Date: April 10, 2014

Objective: CBT-120-UV-C14/-C31 Product Change Notification

The affected products are listed on the table below:

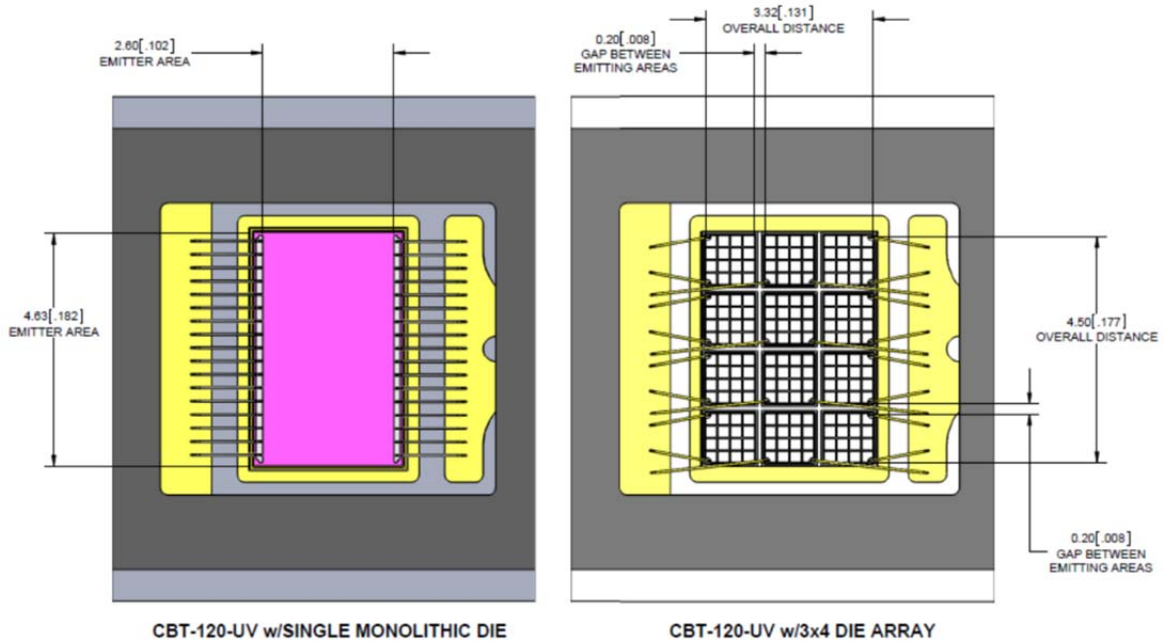
As Luminus continues to consolidate our manufacturing operations as part of the integration efforts with our parent company, Sanan Optoelectronics, we are no longer able to produce some products that your company has purchased in the past 18 months. This letter provides the details for the affected products and the recommended closest replacement. This change is effective immediately and Luminus is not able to offer a last-time-buy opportunity for the affected part numbers.

The suggested replacement parts keep the exact same form factors as the discontinued parts and utilize our new mosaic array chip process. Detailed data sheets for the new products are available on request. Please contact Luminus Technical Support with any questions regarding how to incorporate this new product into your existing designs (techsupport@luminus.com).

Affected Part Numbers	Suggested Replacement Part Numbers
CBT-120-UV-C31-M382-22	CBM-120-UV-C31-I380-21 CBM-120-UV-C31-I385-21 CBM-120-UV-C31-I390-21
CBT-120-UV-C31-N382-22	CBM-120-UV-C31-J380-21 CBM-120-UV-C31-J385-21 CBM-120-UV-C31-J390-21
CBT-120-UV-C31-P382-22	CBM-120-UV-C31-J380-21 CBM-120-UV-C31-J385-21 CBM-120-UV-C31-J390-21
CBT-120-UV-C14-M382-22	CBM-120-UV-C14-I380-21 CBM-120-UV-C14-I385-21 CBM-120-UV-C14-I390-21
CBT-120-UV-C14-N382-22	CBM-120-UV-C14-J380-21 CBM-120-UV-C14-J385-21 CBM-120-UV-C14-J390-21
CBT-120-UV-C14-P382-22	CBM-120-UV-C14-J380-21 CBM-120-UV-C14-J385-21 CBM-120-UV-C14-J390-21
